**STAFF REPORT**  
**Committee of Adjustment**  
**Application**

**File No:** A0572/19NY

**Address:** 113 Ridley Boulevard

# Attachment 1: Site Plan

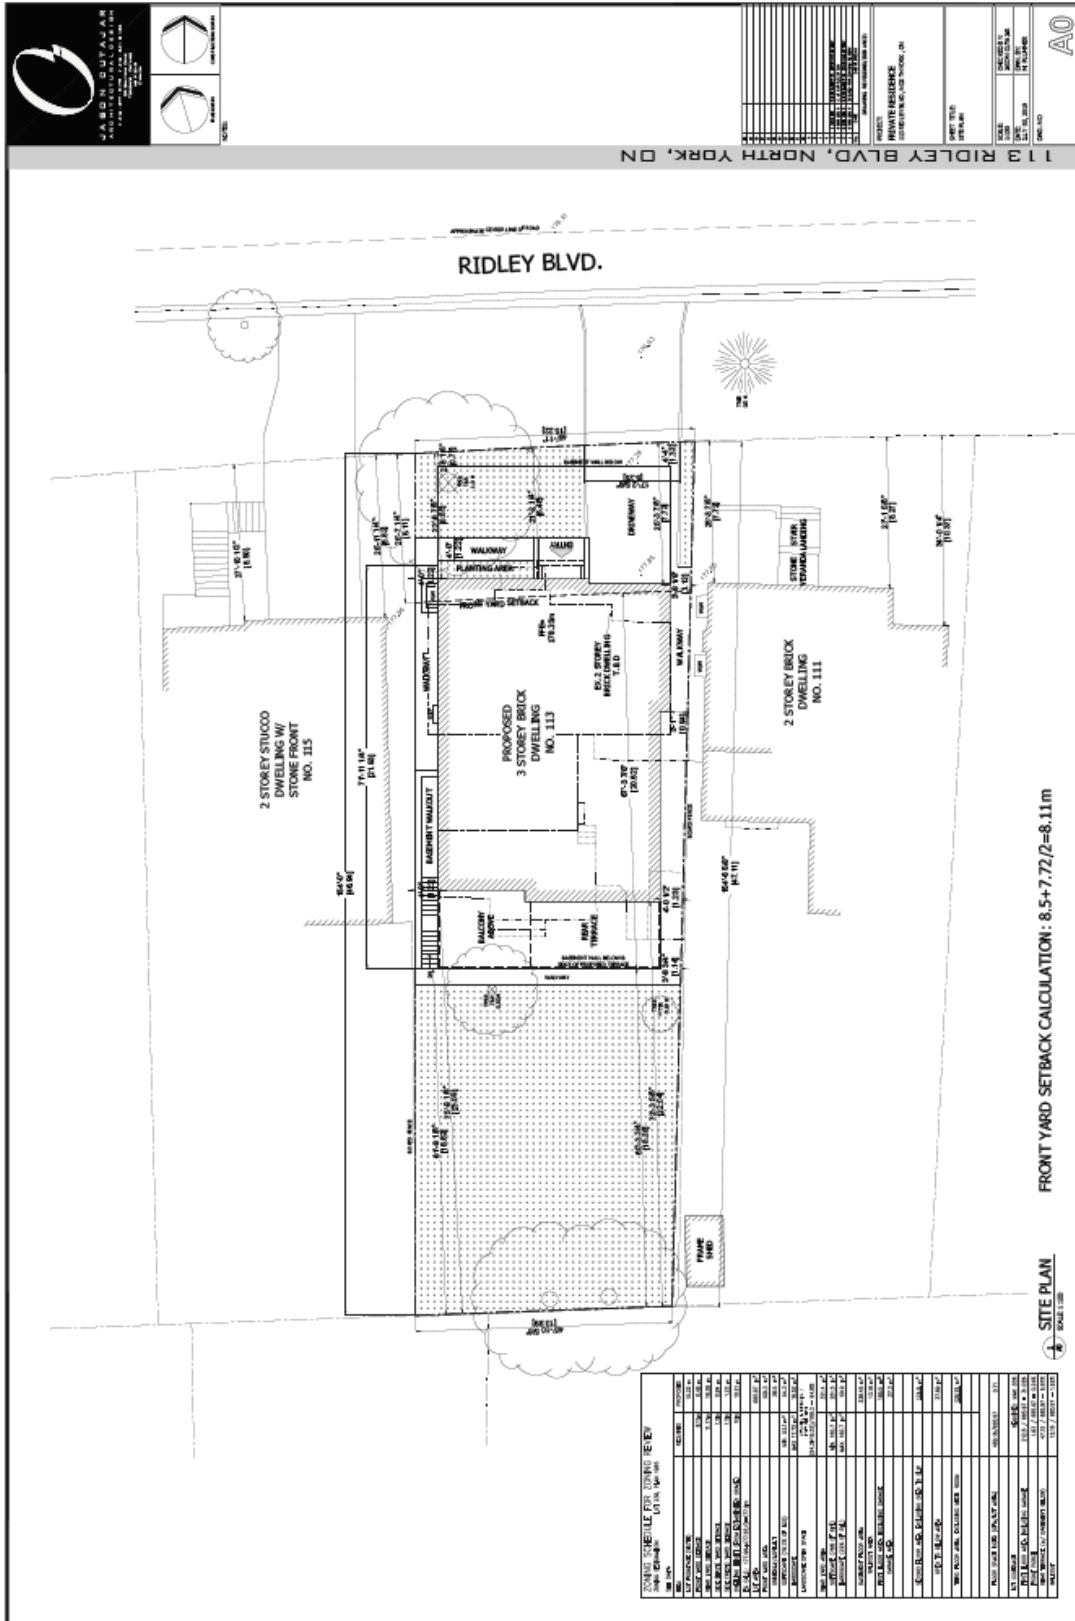
- 1) The property be developed substantially in accordance with the site plan and east side elevation drawings submitted to the Committee of Adjustment, attached as Attachments 1 and 2 to this report.

The application requests variances to permit building length and depth of 27.36 metres and 20.52 metres as measured under Zoning By-law No. 569-2013, whereas the maximum permitted building length and depth are 17 metres and 19 metres, respectively. The 27.36 metres length applies only to the basement. The 21.26 metre length on the first floor is due to the excavated rear terrace. The second and third floors length would not exceed 17.60 metres. In order to ensure the increased building length and depth remain as proposed in the drawings submitted, staff recommend that any approval by the Committee include a condition that the property be developed substantially in accordance with the site plan, and east side elevation drawings submitted to the Committee of Adjustment, and attached as Attachments 1, and 2 to this report.

The application also proposes a side yard setback of 0.94 metres from the east property line as measured under Zoning By-law No. 569-2013, whereas the minimum required side yard setback is 1.8 metres. The applicant previously indicated to staff an intent to

increase the sideyard setback, as stated in planning report dated April 9, 2019, however, the submitted drawing continues to show a side yard setback of 0.94 metre. Side yard setback provisions are devised, in part, to ensure a consistent built form and to ensure adequate provisions for access, stormwater management and maintenance of dwellings. Staff are of the opinion that the requested variance for the east side yard setback is not in keeping with the intent of the Zoning By-law and should be increased to at least 1.2 metres.

- 1) Variance No. 6 related to the east side yard setback to a minimum of 1.2 metres.
